INTERNATIONAL RESIDENTIAL BUILDING/ENERGY CODE

RB2-06/07

FIGURE R301.1.4(1)
TOPOGRAPHIC FEATURES FOR WIND SPEED UP EFFECT

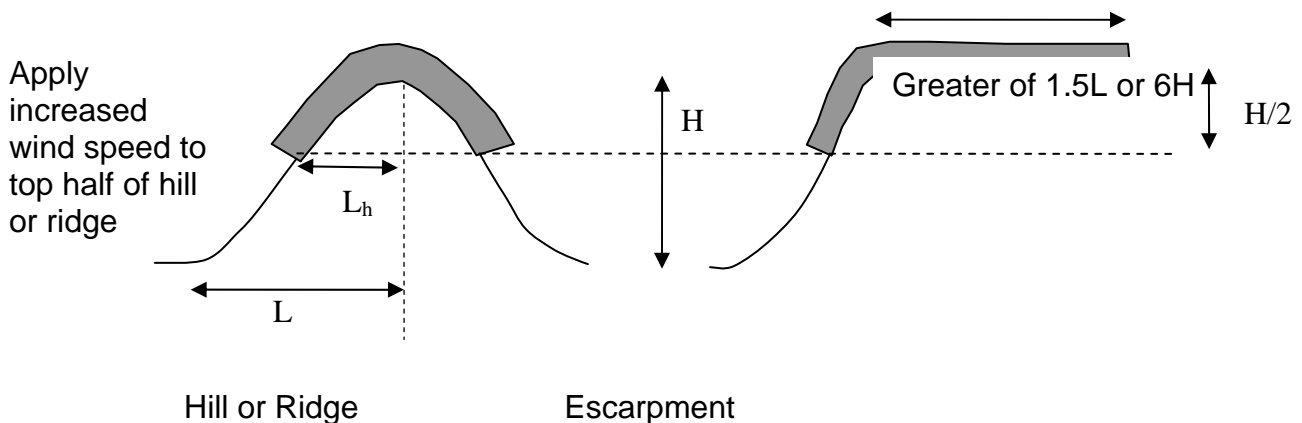
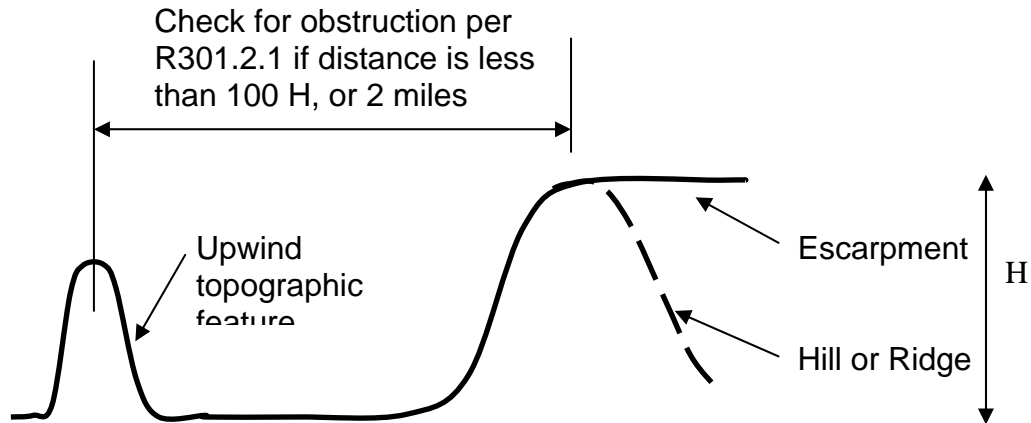
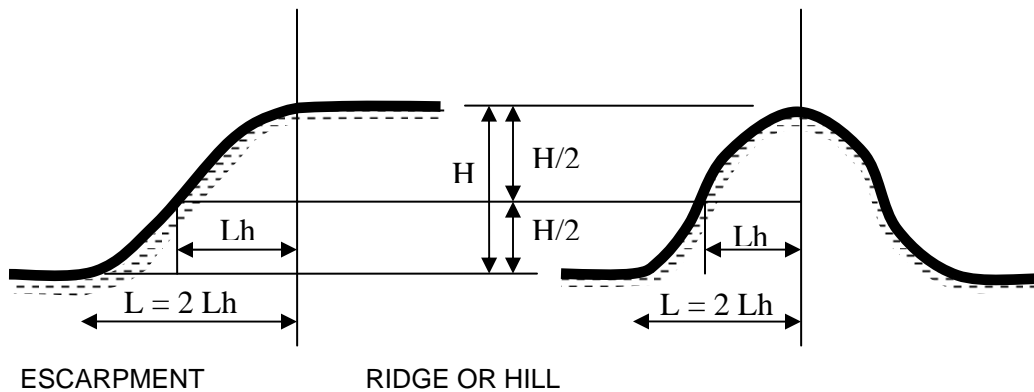
The wind speed up effect is simplified from previous proposals. The main difference is that on closer examination, worst case hills and ridges are so steep and pointy topped that they are essentially un-buildable. Any house at that such a location would for steepness reasons be engineered, and thus have the correct ASCE-7 wind corrections.

FIGURE R301.1.4(1)
TOPOGRAPHIC FEATURES FOR WIND SPEED UP EFFECT

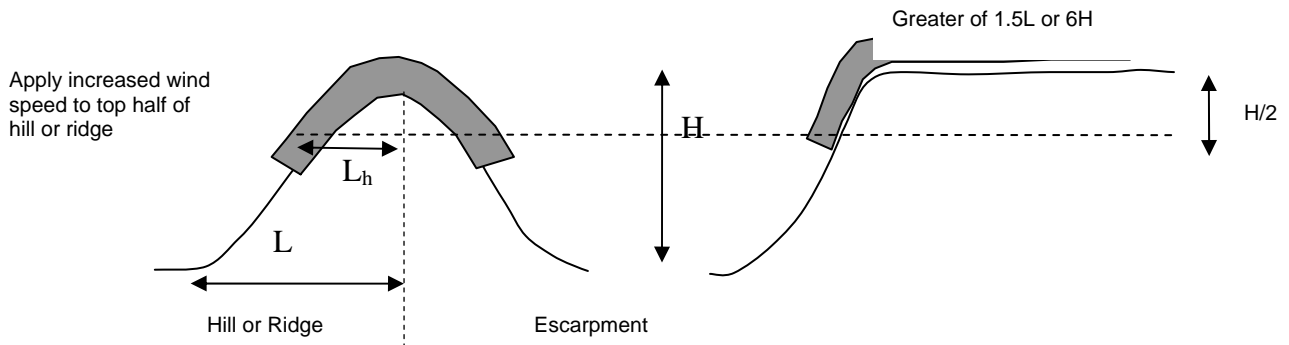
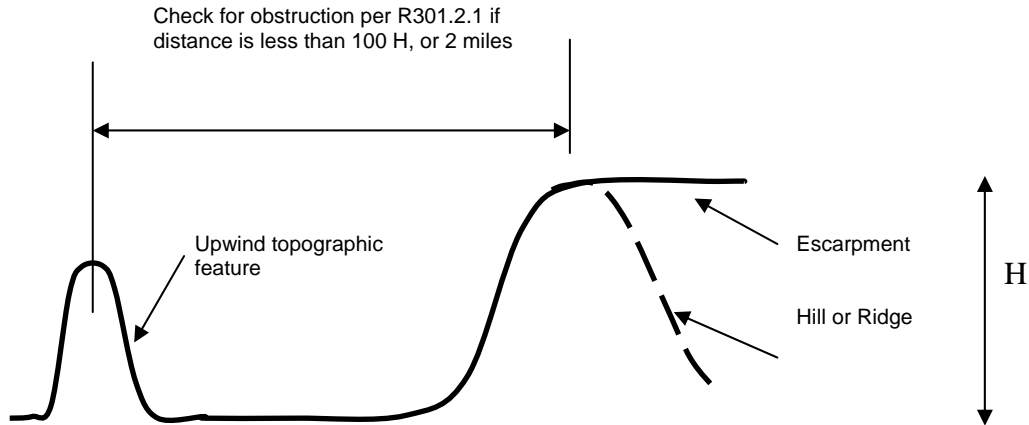
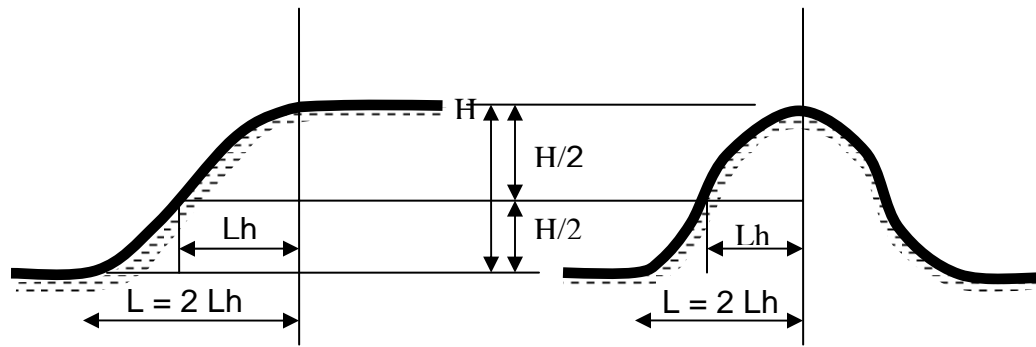
Commenter's Reason: This is the merged RB39 and RB43 that the National Association of Home Builders and the Structural Engineers Association of Washington jointly tried to enter as a floor amendment at the Orlando Code Hearing. It unfortunately was ruled too big a modification to be done as merely a floor amendment.

3. Virtually all of the houses that would require engineering design per ASCE 7, can be done prescriptively when the Simplified Method is used.
4. The Simplified Method is truly that. A designer does not need to figure out if something is a hill, ridge, or escarpment, only that there is a raised area. The design does not require math – it is a simple look-up table. The table has been rounded to standard wind values, so that interpolation is not necessary.
